Subject: NUCLEAR PROJECT NO. 2  
PARTIAL RESUBMITTAL OF DRAFT  
TECHNICAL SPECIFICATIONS

WASHINGTON PUBLIC POWER SUPPLY SYSTEM  
NUCLEAR PROJECT NO. 2

Technical Specifications  
Appendix "A"  
to  
License No. \_\_\_\_

4.2.3 MCPR, as a function of core flow, shall be determined to be equal to or greater than the applicable limit determined from Figure 3.2.3-1:

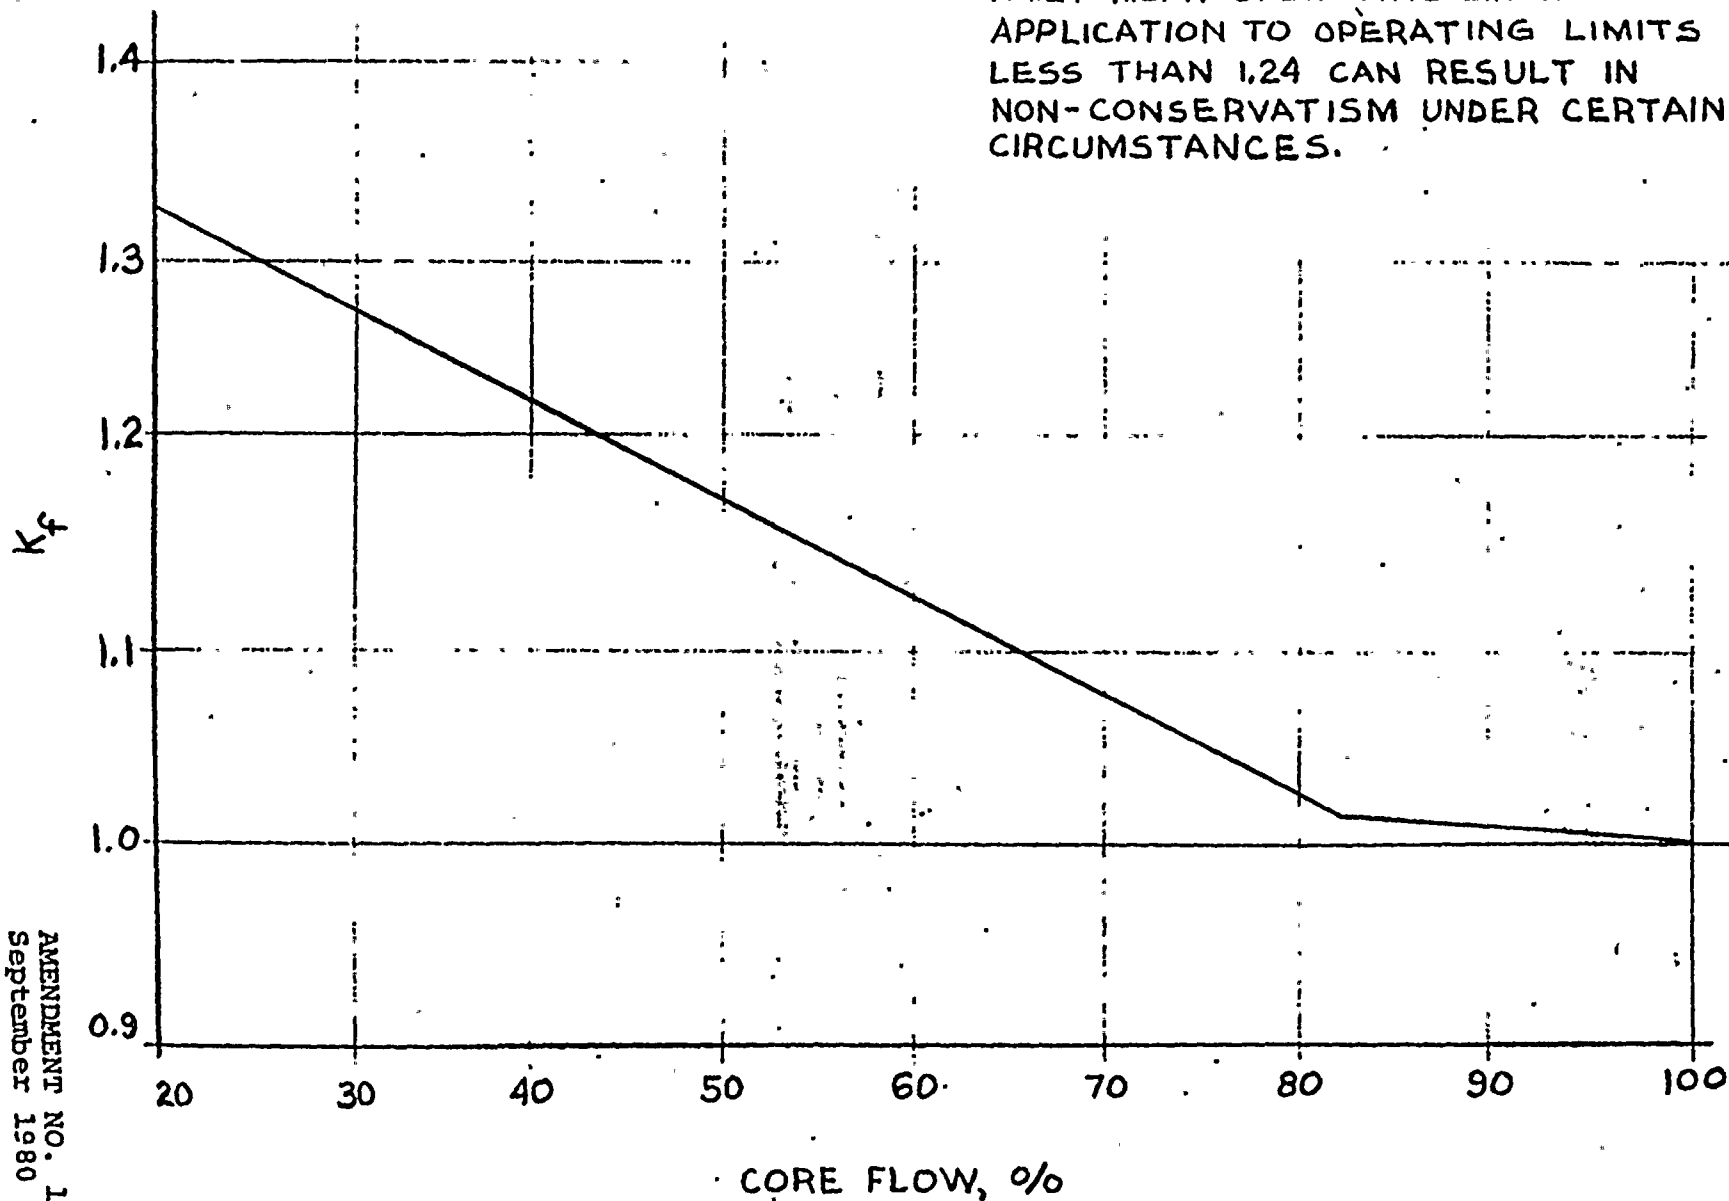
use this for figure 3.2.3-1
